# TOWN OF WELLS, MAINE STAFF REVIEW COMMITTEE

## Meeting Agenda

Tuesday, January 12, 2016, 9:00 AM

### Site Plan Application Memo

ABUTTERS PLAN

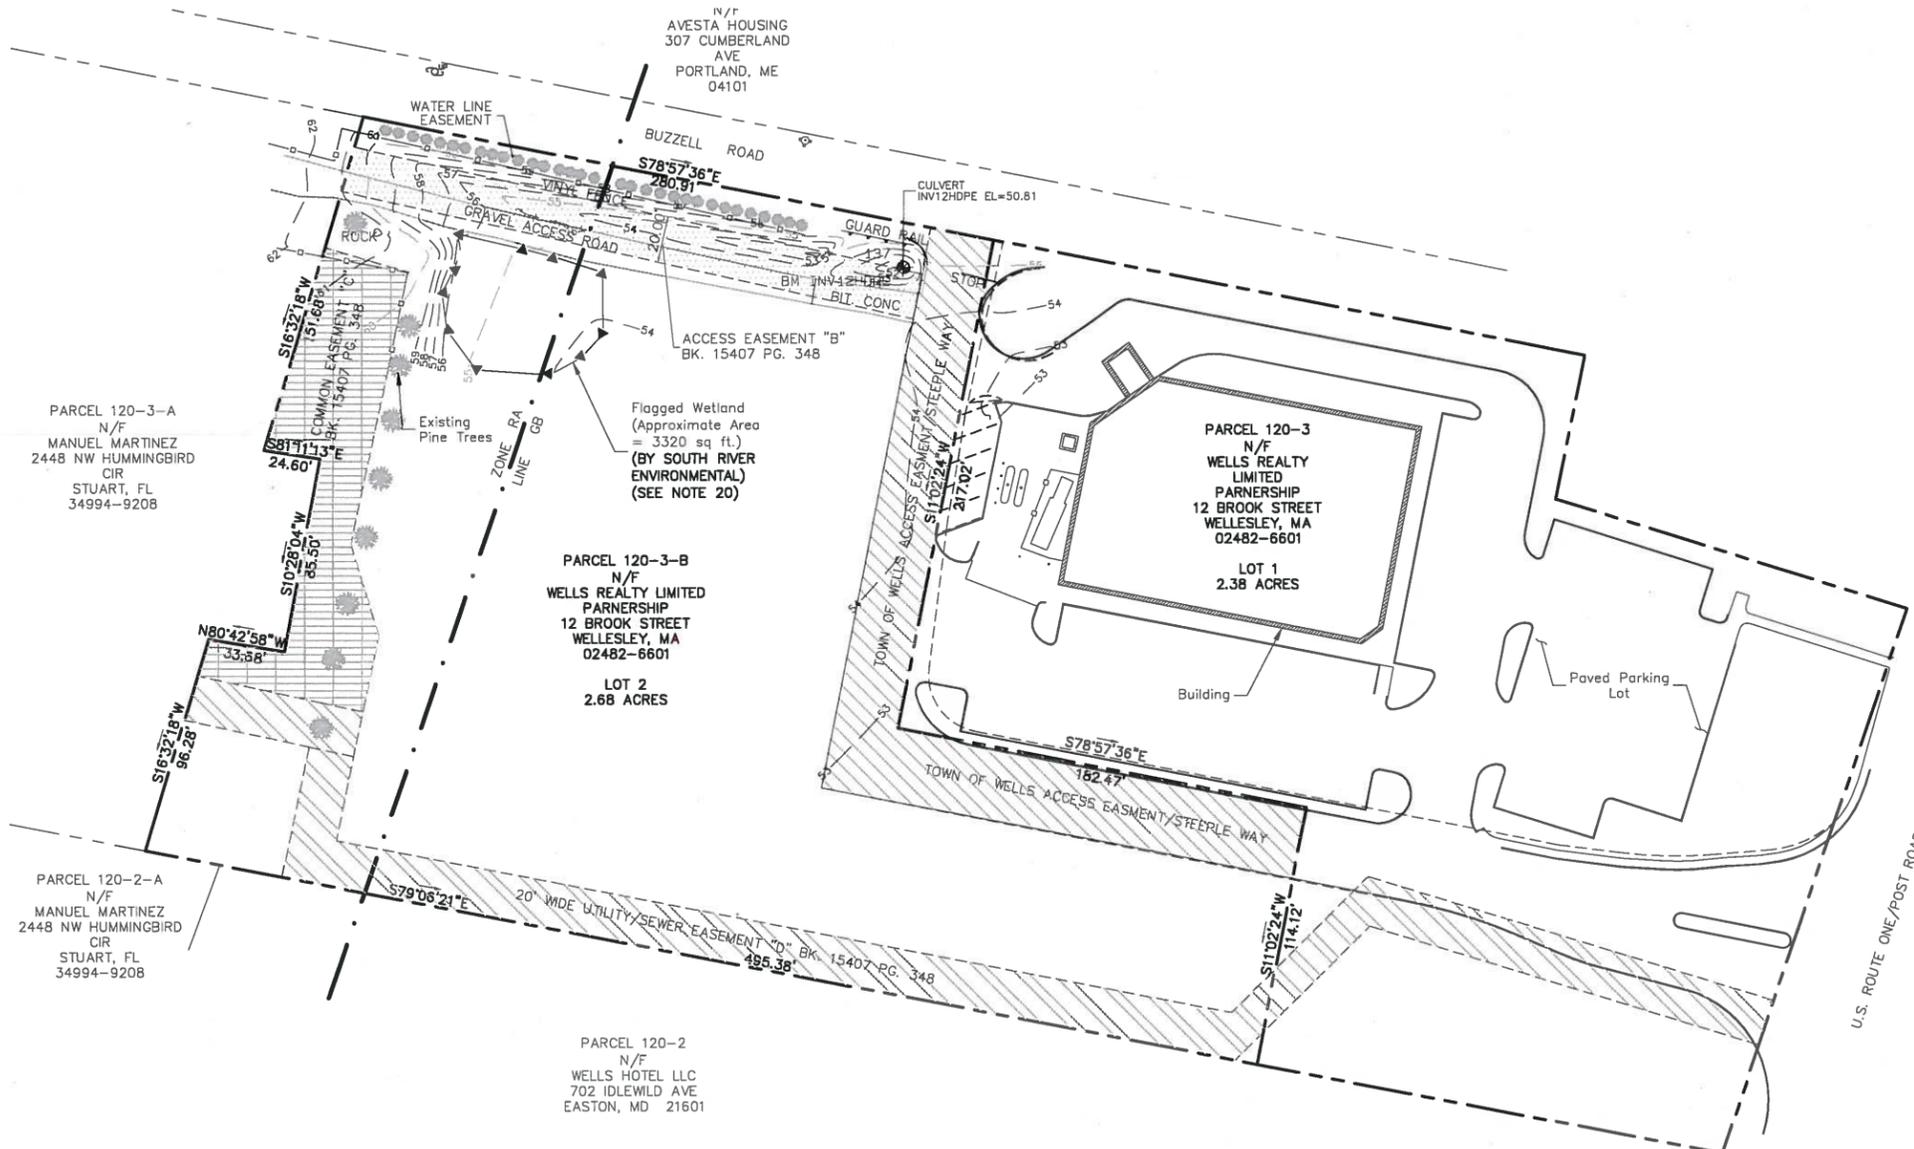
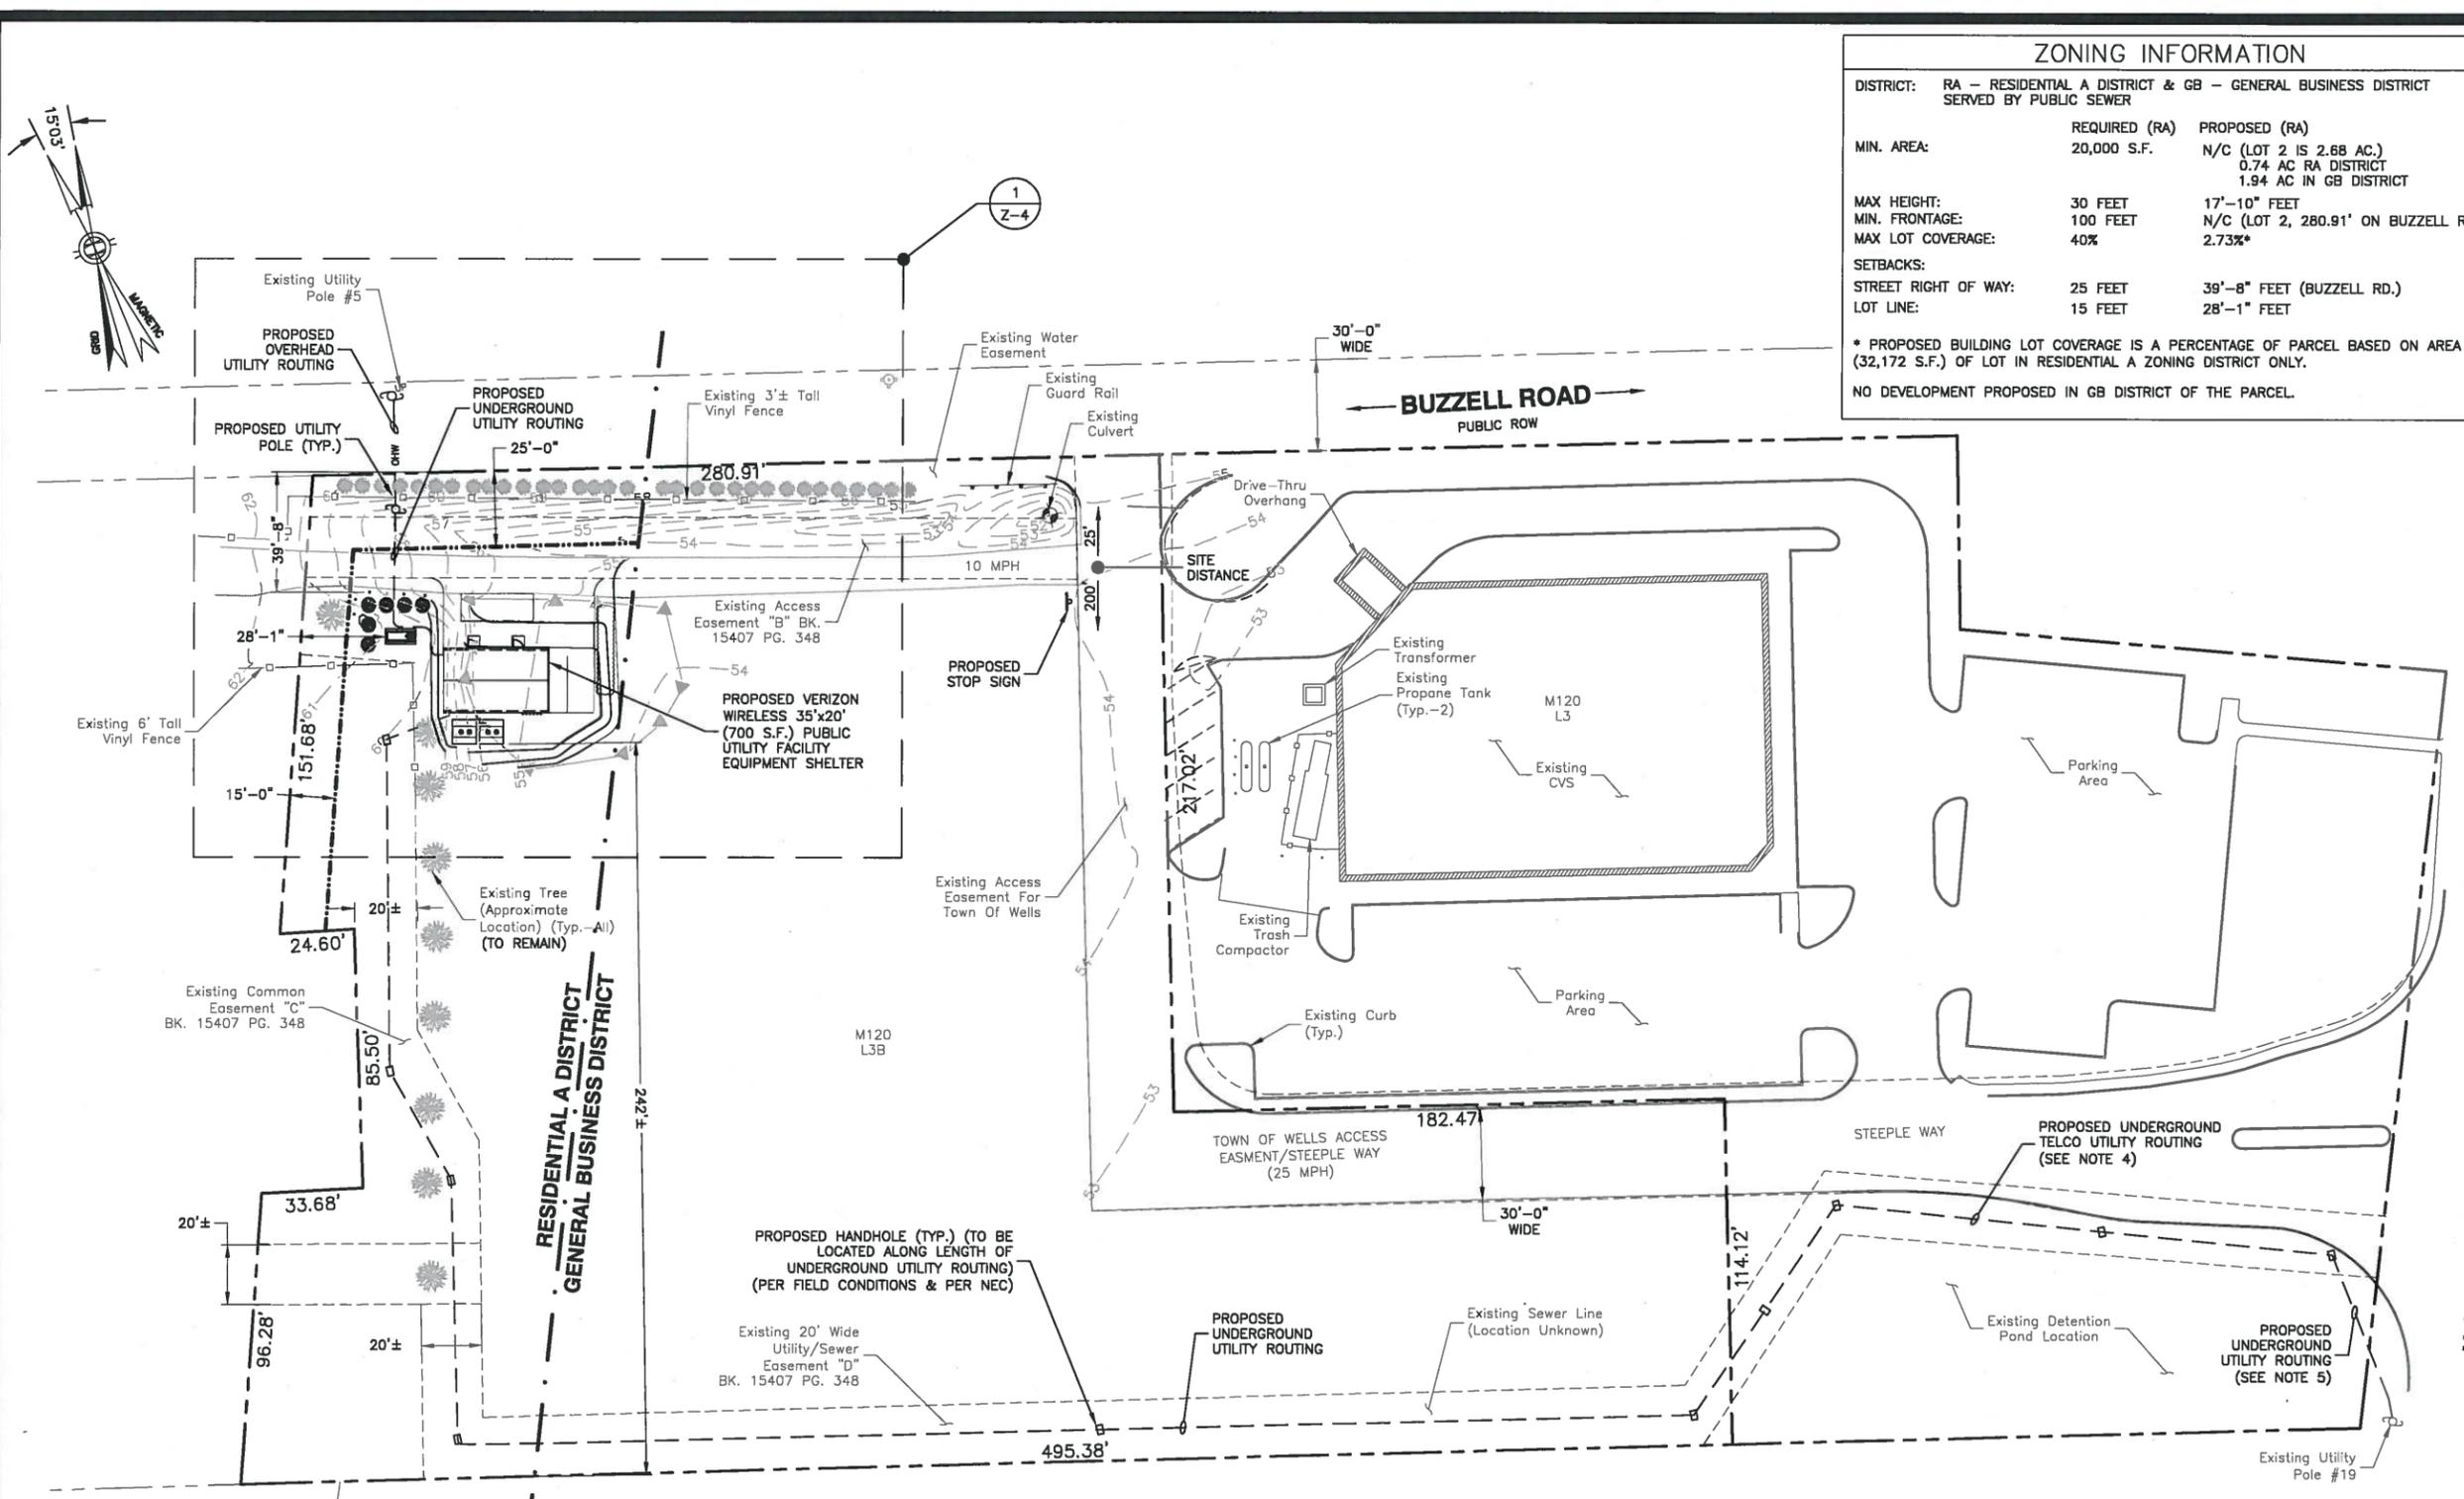
(1) The name and address of the applicant plus the name of the proposed development.	Y				Verizon Head End name noted on the plan sets.
	(2) Total floor area, ground coverage and location of each proposed building, structure or addition.	Y				700 SF proposed Public Utility Facility structure is proposed.  Sheet Z-3 notes the maximum lot coverage allowed to be 40%.  Plan notes that the proposed lot coverage of the RA District is 2.73%. The plan notes that no development is proposed within the GB zone.

(4) All existing and proposed setback dimensions.	Y				See sheet Z-3. Setback lines are depicted on sheets Z-3 and Z-4.
	(5) The size, location, direction and intensity of illumination of all major outdoor lighting apparatus and signs.	Y*				The standard sign notes on sheet Z-4. <b><u>Light and glare note to be added to sheet Z-4.</u></b>

(14)	The lot lines of all lots abutting the proposed development, including those lots across the street, together with the names on file in the Town offices as of the date of the application.	Y				See sheet Z-1 for abutters information.

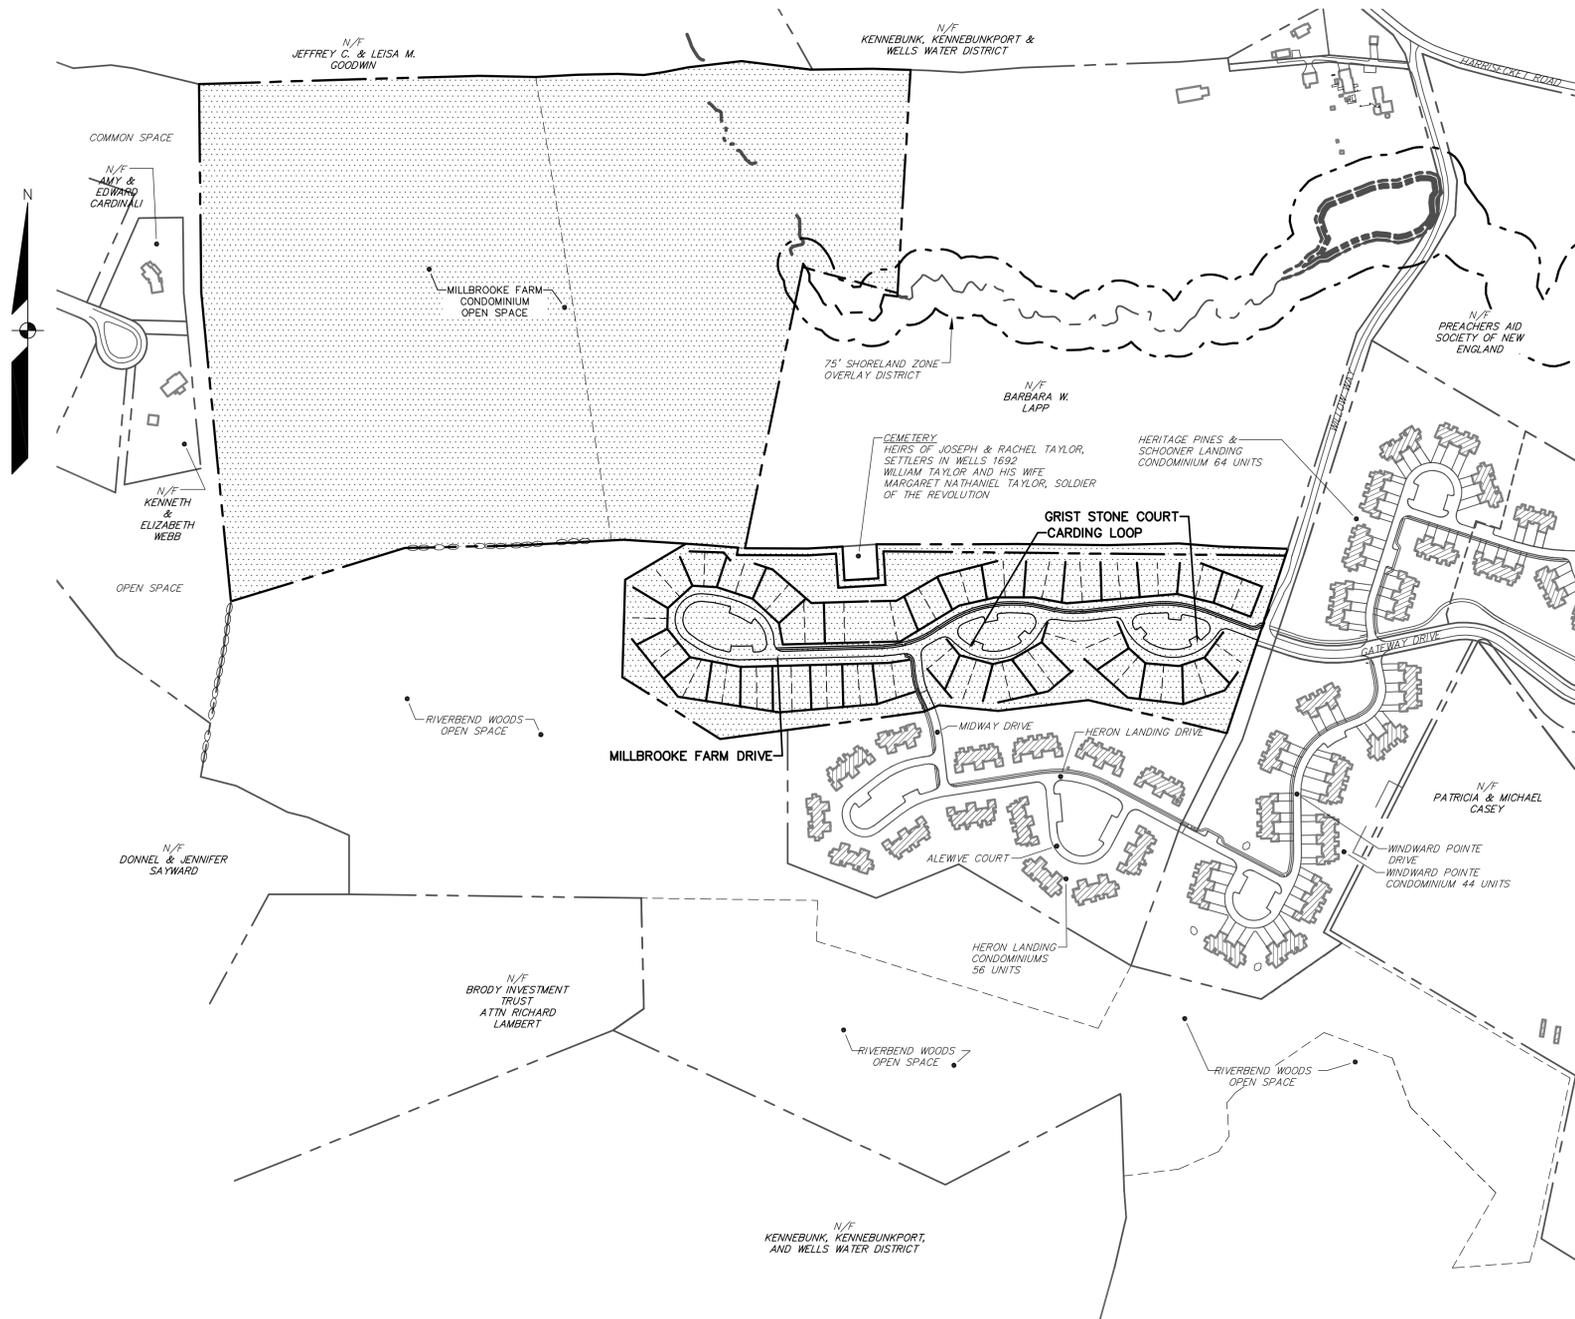
- b. Cemetery ownership (take shading off of sheet 1), State unknown if unknown

***Response: Shading has been removed from Sheet 1 and cemetery ownership has been added.***
